Addendum 128 – UN Regulation No. 129

Revision 3 - Amendment 7

Supplement 8 to the 02 series of amendments – Date of entry into force 5 June 2023

Uniform provisions concerning the approval of Enhanced Child Restraint Systems used on board of motor vehicles (ECRS)

Figure 1
Conditioning for adjusters mounted directly on Enhanced Child Restraint Systems

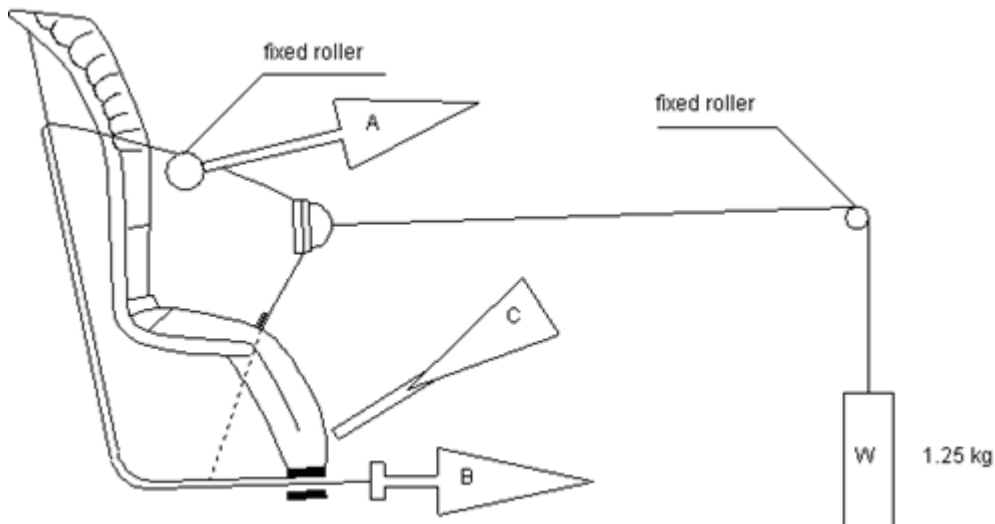
Annex 15, amend to read:

1. Conditioning for adjusters mounted directly on Enhanced Child Restraint Systems (Figure 1)
 - 1.1. Method
 - 1.1.1. With the webbing set at the reference position described in paragraph 7.2.6.1., withdraw at least 50 mm of webbing from the integral harness by pulling on the free end of the webbing.

- 1.1.2. Attach the adjusted part of the integral harness to the pulling device A.
 - 1.1.3. Activate the adjuster (C) and pull at least 150 mm of webbing into the integral harness. This represents half of one cycle and puts pulling device A to the maximum webbing extraction position.

- 1.1.4. Connect free end of webbing to pulling device B.
 - 1.2. The procedure of the cycle is:
 - 1.2.1. Pull B at least 150 mm while A exerts no tension on the integral harness.

- 1.2.2. Activate the adjuster (C) and pull A while B exerts no tension on the free end of the webbing.
 - 1.2.3. At the end of stroke, de-activate the adjuster.

1.2.4. Repeat cycle as specified in paragraph 6.7.2.7. of this Regulation.

Figure 2

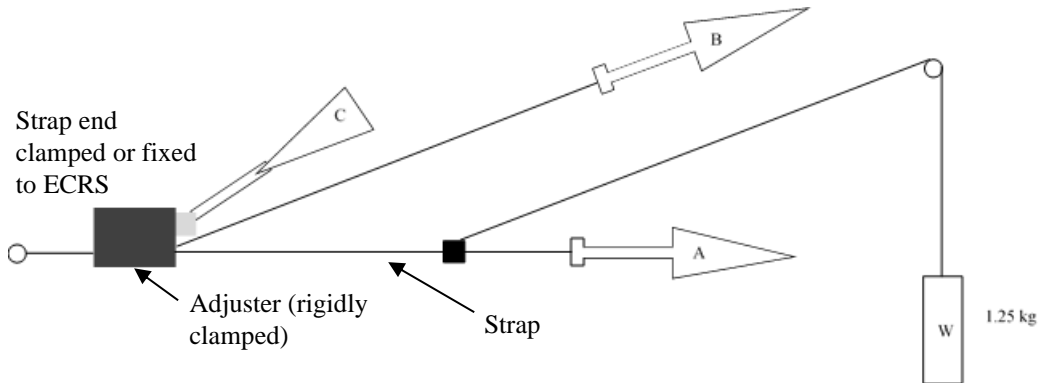
2. Conditioning for adjusters connected to a strap (not directly mounted on Enhanced Child Restraint Systems) (Figure 2)

2.1.1. Rigidly clamp the adjuster

2.1.2. With the strap set at the reference position described in paragraph 7.2.6.2., withdraw at least 50 mm of strap from the adjuster by pulling on the free end of the strap.

2.1.3. Attach the adjuster part of the strap to the pulling device A.

2.1.4. Activate the adjuster (C) and pull at least 150 mm of strap through the adjuster. This represents half of one cycle and puts pulling device A to the maximum strap extraction position.

2.1.5. Connect the free end of the strap to pulling device B.

2.2.1. Pull B at least 150 mm while A does not exert tension on the strap.

2.2.2. Activate the adjuster (C) and pull A while B does not exert tension on the free end of the strap.

2.2.3. At the end of the stroke, de-activate the adjuster.

2.2.4. Repeat the cycle as specified in paragraph 6.7.2.7. of this Regulation."
